CAMPAIGN BULLETIN

05-586-09

Models Affected: HR37 & HR40 Aerials

SUBJECT: *Rod Weldment of 437250D Main Lift Cylinder*

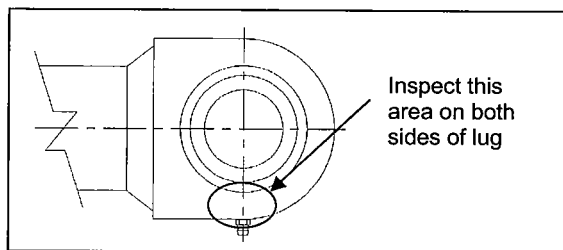
Terex Utilities has determined that material supplied for the lower boom lift cylinder rod eye on certain 437250 cylinders is not to specification and can fail. The supplier involved provided rod eye material used on HR37 or HR40 units built between 6/21/1999 through 1/30/2001.

If the cylinder rod eye fails the boom and platform will fall.

The owner or user must immediately perform a visual inspection of the cylinder rod eye in the area of the grease zerk. Clean off the dirt and grease to determine if a crack is evident near the ball bushing. If there are any indications of a crack remove the unit from service and contact Terex Utilities at 605-884-3892. If no cracks are detected contact the nearest Terex Utilities dealer to arrange replacement of the cylinder rod within 45 days. You may continue to use the unit if you inspect the rod eye daily to determine that no cracks are present.

Inspect Lift cylinder rod end in this area on both sides. Clean off dirt and grease to see side of lug down to the bushing bore.

Affected units, as shown on the owner letter, will have the cylinder rod replaced at no charge to the owner. Repair parts will be available beginning 5/15/09. All 437250D cylinder rods with the date codes listed above will be replaced.
